## Department of Transportation

49 CFR Parts 213 and 238

Vehicle/Track Interaction Safety Standards; High-Speed and High Cant  
Deficiency Operations; Final Rule

**ACTION:** Final rule.

Figure 1 of Appendix D to Part 213

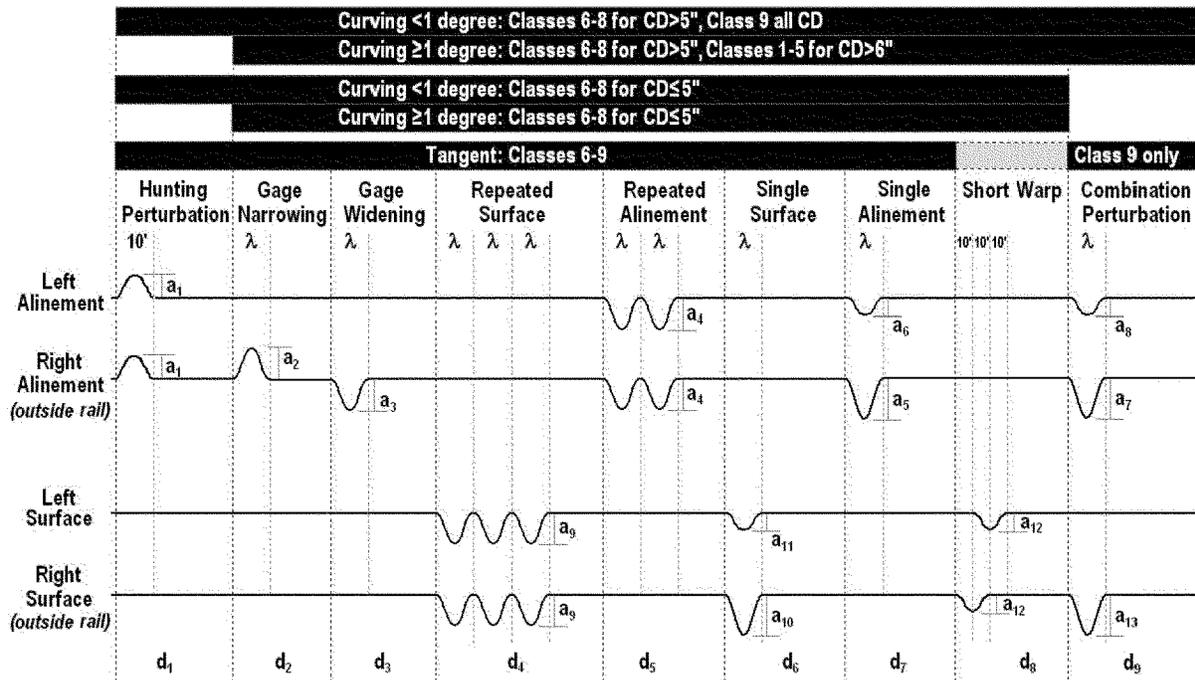
Paragraph (b) specifies the layout of the MCAT segments. Bombardier submitted a number of comments on proposed paragraph (b), first taking issue with the last sentence in proposed (b)(1)(i) that the hunting perturbation segment would be used only on tangent track simulations. Bombardier noted that the proposal was inconsistent with paragraphs (c)(3) and (4) of this appendix, which would require that the hunting segment be used on curves less than 1 degree, and that, as a result, a revision to paragraph (b)(1)(i) or a footnote to figure 1 would be needed to address this inconsistency.

In addition, Bombardier commented that the text in proposed paragraph (b)(1)(ix) concerning the combined perturbation segment was inconsistent with § 213.332, Combined track alinement and surface deviations, which has been adopted in this final rule. The text of proposed paragraph (b)(1)(ix) limited its application to curved track segments, while § 213.332 addresses combined track alinement and surface deviation limits for Class 9 track, either curved or tangent. Bombardier noted that a revision to paragraph (b)(1)(ix) or a footnote to figure 1 was needed to address this inconsistency. In response to this comment, paragraph (b)(1)(ix) has been modified to make clear that the segment is to be used for all simulations on Class 9 track. In addition, figure 1 has been modified so that it reflects application of the combined perturbations segment to tangent cases on Class 9 track. These changes make this appendix consistent with § 213.332.

In response to this comment, paragraph (b)(1)(i) is being revised to make clear that the hunting perturbation segment applies both to tangent track and to track that is curved less than 1 degree. Figure 1 is also being modified accordingly to show that the hunting perturbation section must be included for curves less than 1 degree. The modifications to figure 1 and the text in paragraph (b)(1)(i) reference under what curvature conditions the hunting segment is to be used. Since the curvature value is calculated using a combination of speed and cant deficiency, there is no need to specify which track classes need to include this section in curving simulations.

As noted, the MCAT layout in figure 1 has been modified to clarify which segments are required depending on the speed and the degree of curvature involved. In particular, the hunting perturbation segment is not required for simulations of curves greater than or equal to 1 degree; the short warp segment is not required for tangent track simulations; and the combined perturbation segment is required on tangent track only for Class 9 track, and is not required for simulations of no more than 5 inches of cant deficiency other than for Class 9 track, where it is required for all cant deficiency values.
